MEMORANDUM

CASE NO. PD-270-RBN, The Avenue at Denton Tap

REQUEST: A zoning change to PD-270-RBN (Planned Development-270-Residential Urban Neighborhood), to allow 29 multifamily units and 8,575 square feet of office/retail uses.

Mock City Council Meeting March 21, 2018

Site Plan

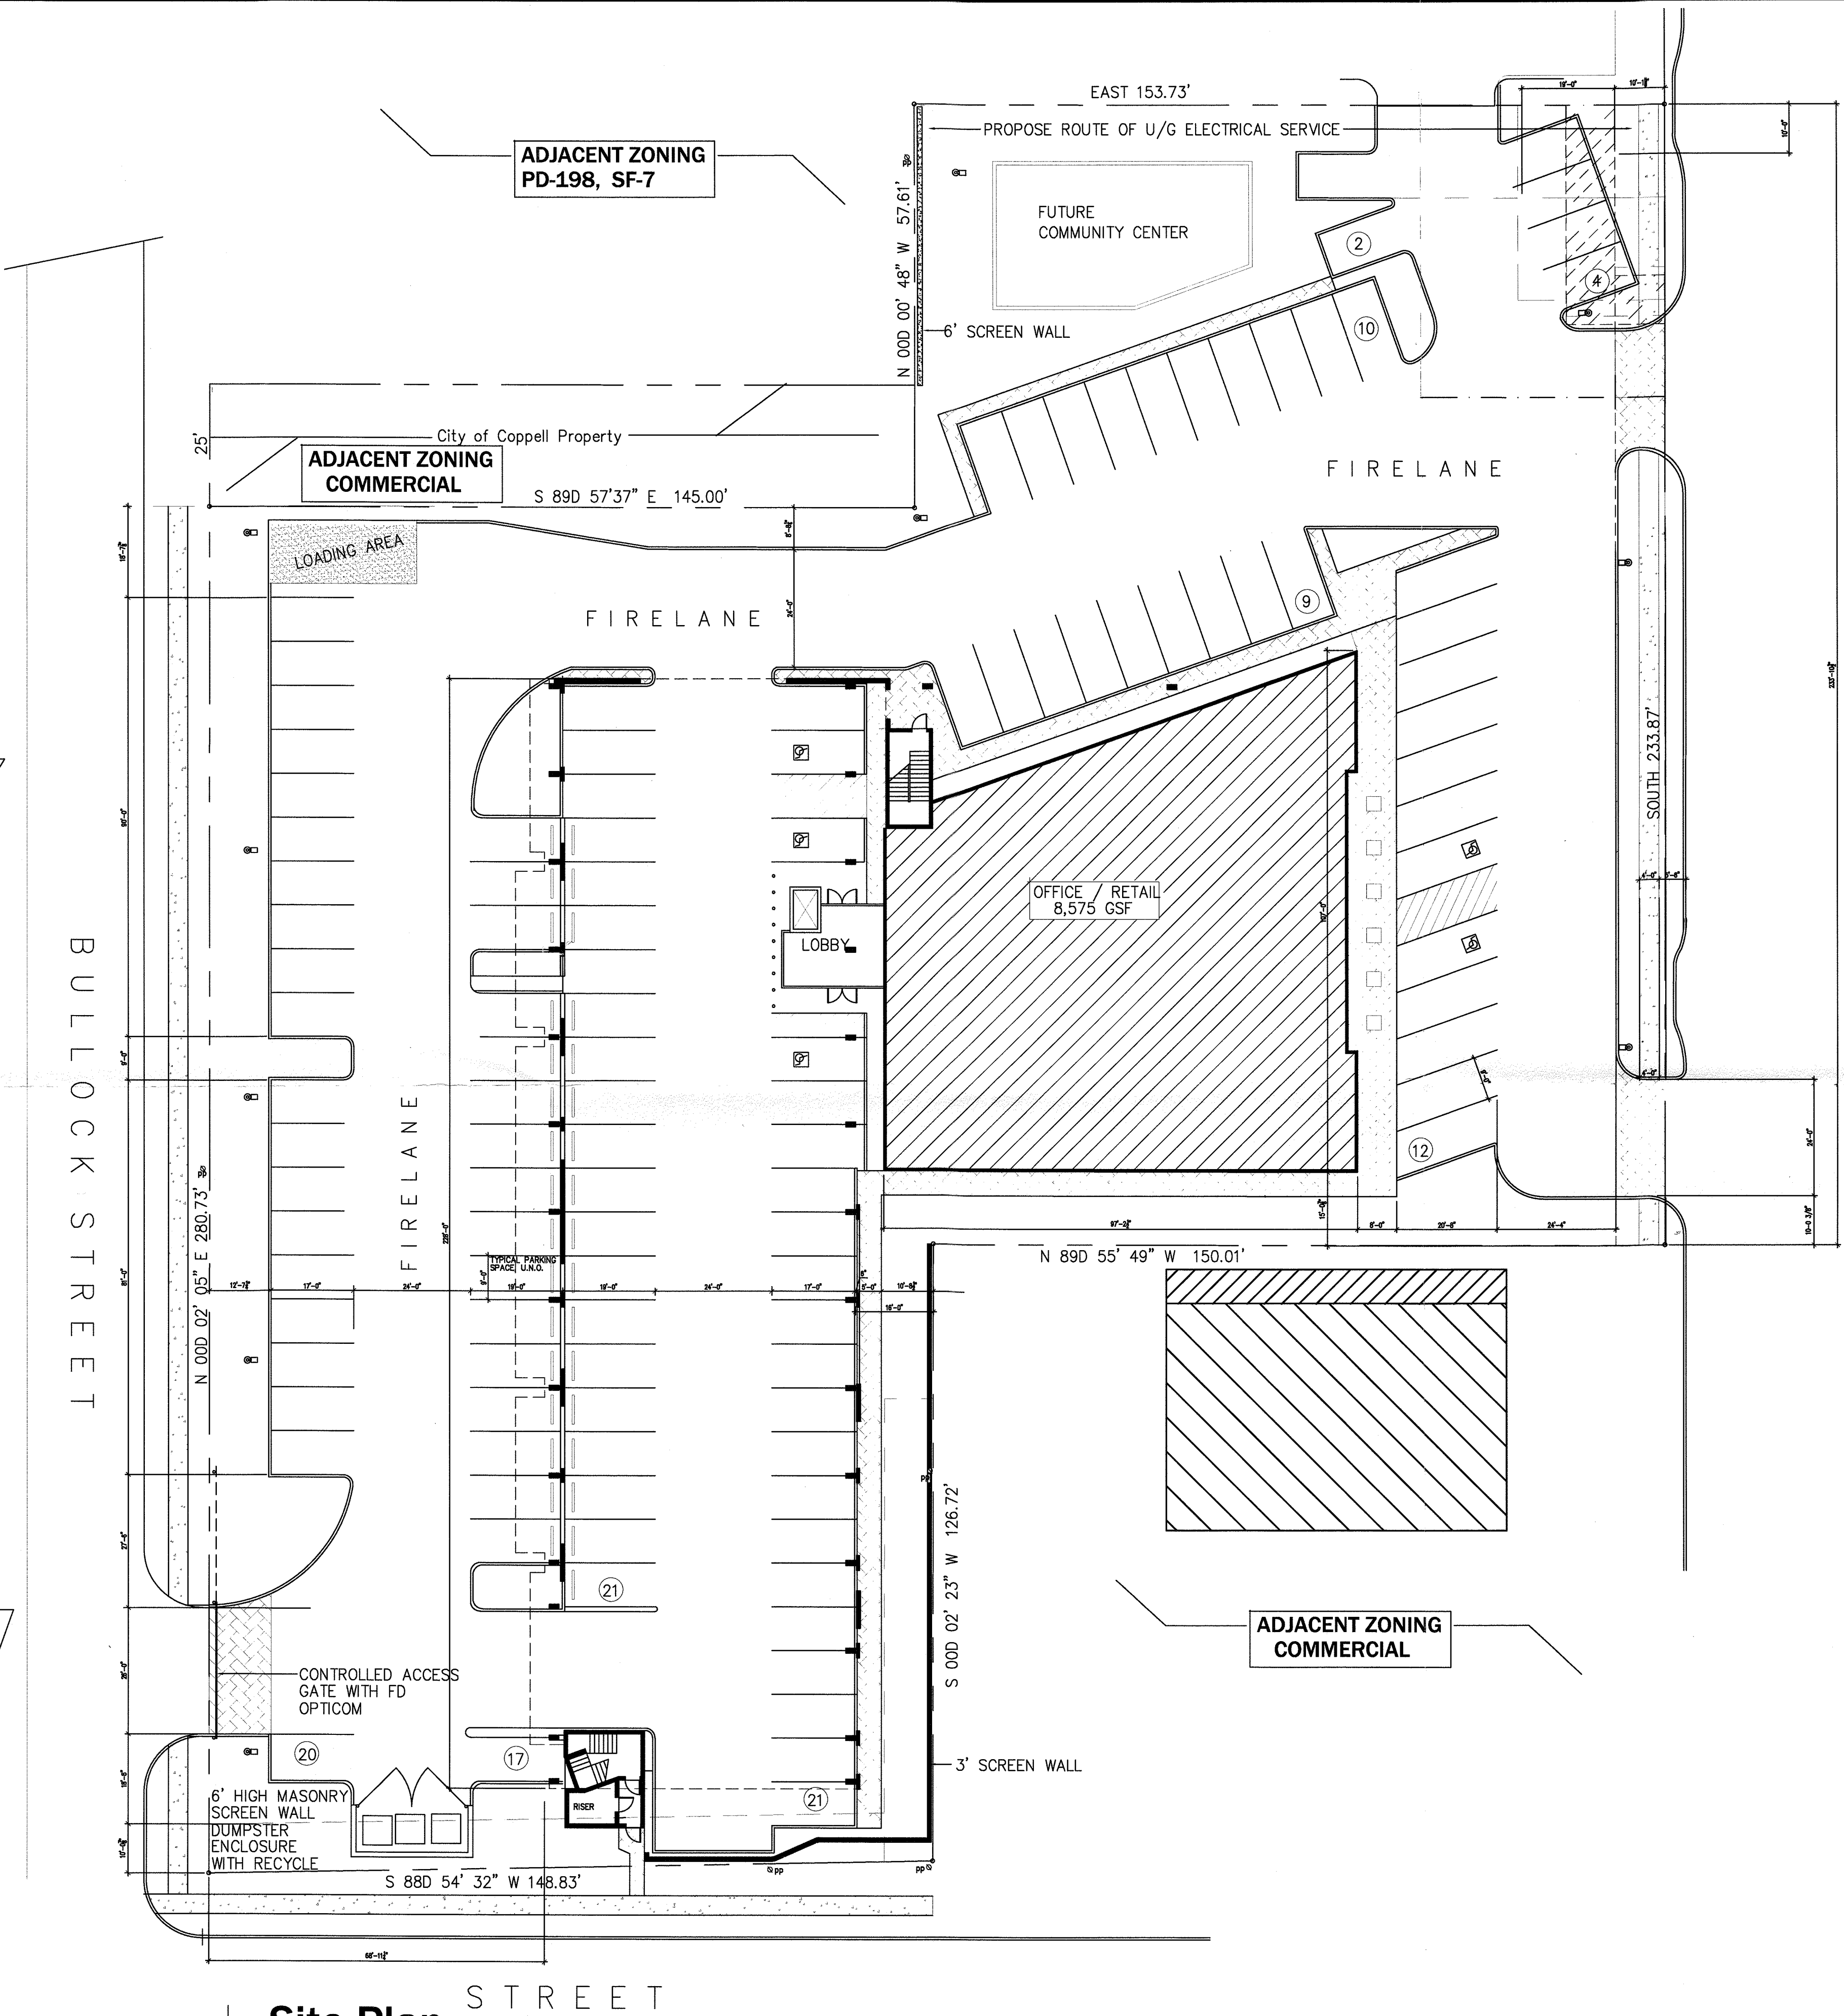
This building is proposed to be setback 63 feet from Denton Tap Road and 69 feet from Bullock Street. It is recommended that the 69-foot setback be supported to keep a buffer and transition from the residential neighborhood into the proposed higher intensity mixed use development.

A 36-foot setback is proposed along the northwest property line, which is adjacent to a 25-foot right-of-way providing a greater separation from the residential neighborhood. The main building is 63 feet from the Denton Tap Road right-of-way where the RBN District calls for a building to be no more than 15 feet from the lot line. Staff can support this deviation, as both a drive and parking are warranted for the office/retail use.

This proposal exceeds the 116 parking space requirement by providing 119 spaces. Both the *Comprehensive Plan* and the RBN District encourages structured (garage) parking. In this development 41 of the 119 spaces are contained within the structure. It is recommended that this parking area on the first floor be better screened with a three-foot masonry wall incorporated into each façade and this has

been listed as a condition of approval. Beyond the structured parking are 41 spaces in a parking lot. This area is proposed to be screened with a 12 foot wide landscaped area east of Bullock Street. The proposed off-street parking and drive (similar to a slip street recognized in the Comprehensive Plan). The proposed parking located on the Denton Tap Road side is angled with a one-way drive to provide an opportunity for streetscaping without actually having dangerous on-street parking on Denton Tap.

| 8. | Include three 150-square-foot landscape islands with an overstory tree within the proposed surface parking area where not under the structure. No more than 15 spaces are typically permitted without an island and one island is required at the end of each parking row. |
| 16. | Include a gate with controlled access (include opticom for Fire Department) at the southwest access point off of Bullock. |
| 17. | Relocate the dumpster enclosure to the south end of the project. |

1 LANDSCAPE PLAN
SCALE 1"=20'

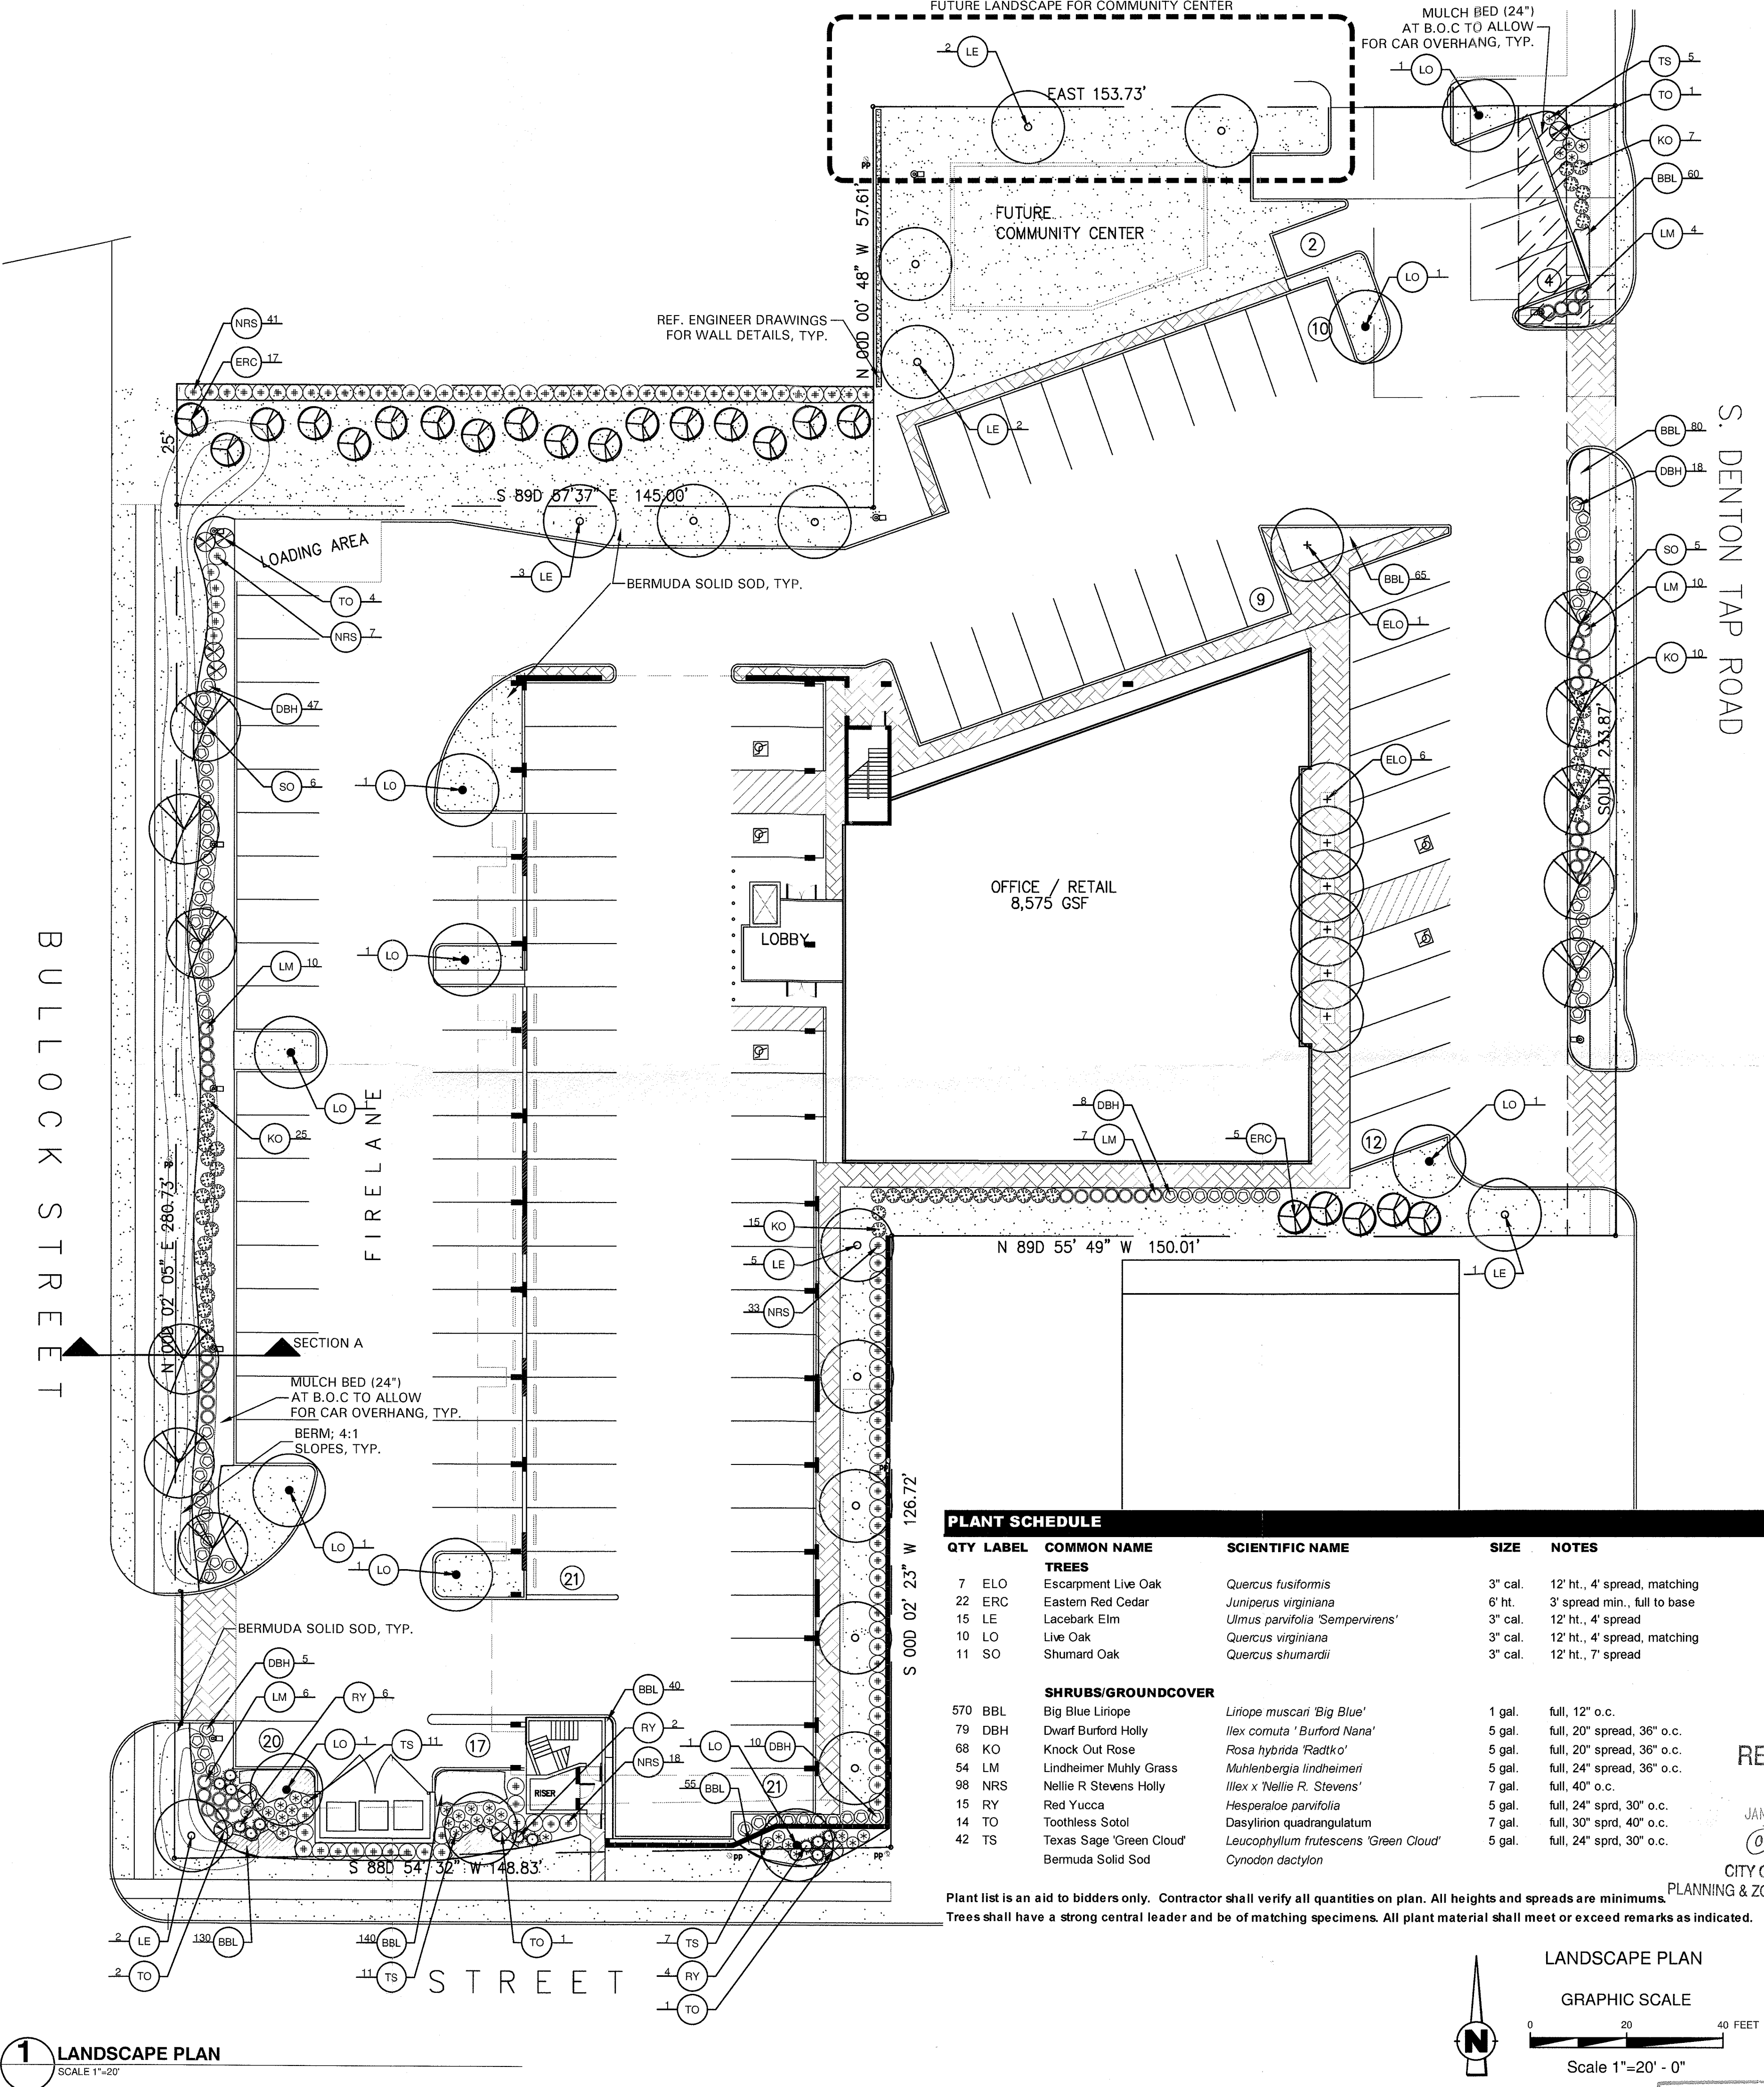
The landscape areas within a RBN District are different than the typical business zoning districts where under the RBN, a minimum 15% open space/common area is required. The proposal indicates that 17% has been provided. The streetscaping of the retail/office area is adequate where street trees are being provided. However, additional landscape islands are being recommended in the parking lot where there is no structure over the parking. Not more than 15 parking spaces are typically permitted without an island and one island is required at the end of each parking row; therefore, three islands are recommended. Also, the applicant has agreed to add an evergreen area of landscaping (containing Nellie R. Stevens and Eastern Red Cedars) to the 25 foot right-of-way strip located northwest of the property to better buffer/screen this proposal from the existing residential neighborhood.

| 12. | Label the 25-foot right-of-way northwest of the site as City of Coppell Property. Include Eastern Red Cedars and Nellie R. Stevens south of the existing fence. |
| 15. | Revise the Landscape Plan to include interim and future landscaping for the "Future Community Center" portion of the site. |
